Ref. No. 201512011
Petition No. 552

REQUEST BERM USE
 (For Parking Only)
 INTO JOY RD.
 AT 14516 JOY RD.

JOY - STRATHMOOR
PARKING

DRWG. NO. X 552

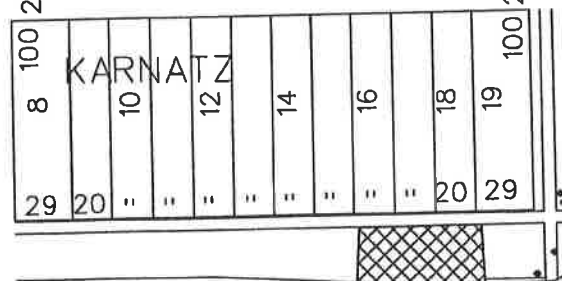
- (X) Involved; have no objection to the request for berm use (for parking only) into Joy Rd. at 14516 Joy Rd. as shown on drawing no. x552 dated 03-12-2015 provided that the following conditions are met with:

- (1) In order to delineate the parking area and to make it safe for pedestrian and vehicular traffic adjacent to it, the petitioner shall be responsible to install and maintain continuous concrete stoppers painted in yellow color along the edge of the concrete berm adjacent to the grassy area just west of it, along the edge of the sidewalk just north of it, and along the edge of the paved roadway just south of it as shown on the attached drawing.

- (2) It shall be the petitioner's responsibility to maintain at all times, a minimum 6 ft wide clear sidewalk in front of 14516 Joy Rd.
 - (3) Since this is a special case granting permission for berm use only for parking of employees' vehicles, the petitioner will be responsible to install a sign stating the same.
